## ORIGINATION FORM

### Proposed Revisions to a Standard Plans Index (Please provide all information — Incomplete forms will be returned)

Index Number: 700-030

Index Title: Wind and Hanger Beams for Overhead Signs

**HANGER TABLE (I 6 X 4 x 4.69 or Z 5 x 3 1/4 x 4.01)**

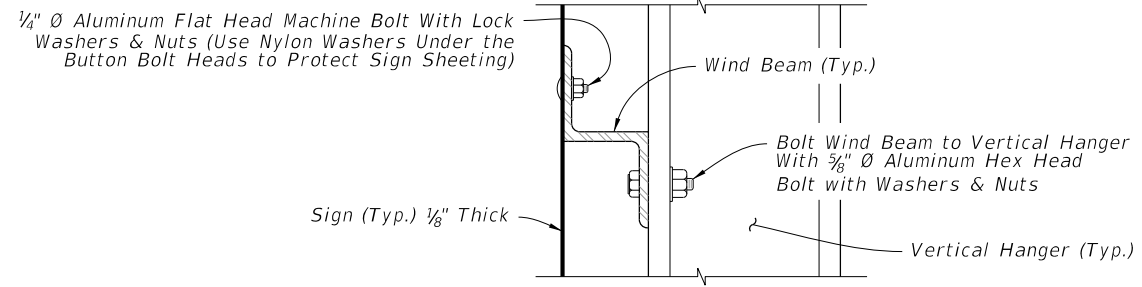
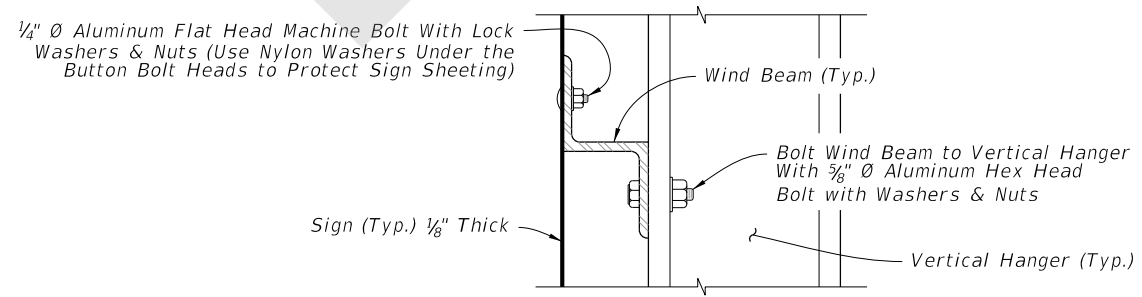
Change Note 6.A.b reference to ASTM B308 to ASTM B221 throughout Standard Plans as an administrative change.  
Corrected Title block of Hanger Table.

I-beam size label was incomplete as previously shown. Should be I 6x4x4.69 and Z 5/3.25 x 4.01
